工程指示 / 要求簡箋(E.I.)

工程指示編號：EI / 5413 / 22

工程名稱：將軍澳日出康城

工程項目：吊機吊船 地盤用鐵件 (3mm 鐵板)

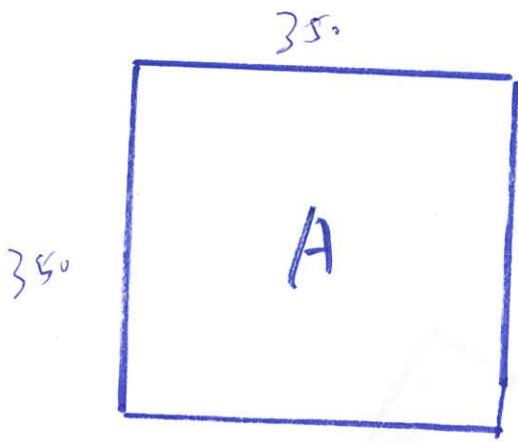
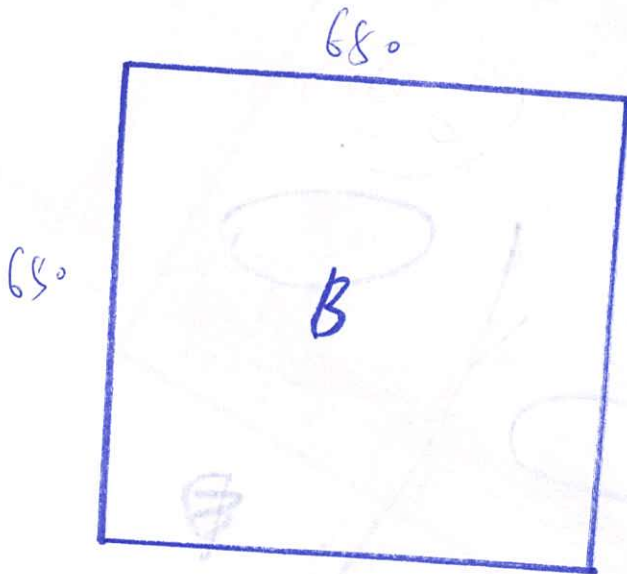
按 Aecom R.E 放寬 comment 減厚度，鐵板用 3mm。

請準備以下鐵料到送地盤 (不用熱浸鋅，黑鐵，油紅丹) 後面用 A: 350x350x3 厚：90 件
每輛計 前掌用 B: 650x650x3 厚：25 件

現來 11 winch 和 5 船 第一批 驗機、驗船用

3mm

尾石用

3mm

前堂用

25个
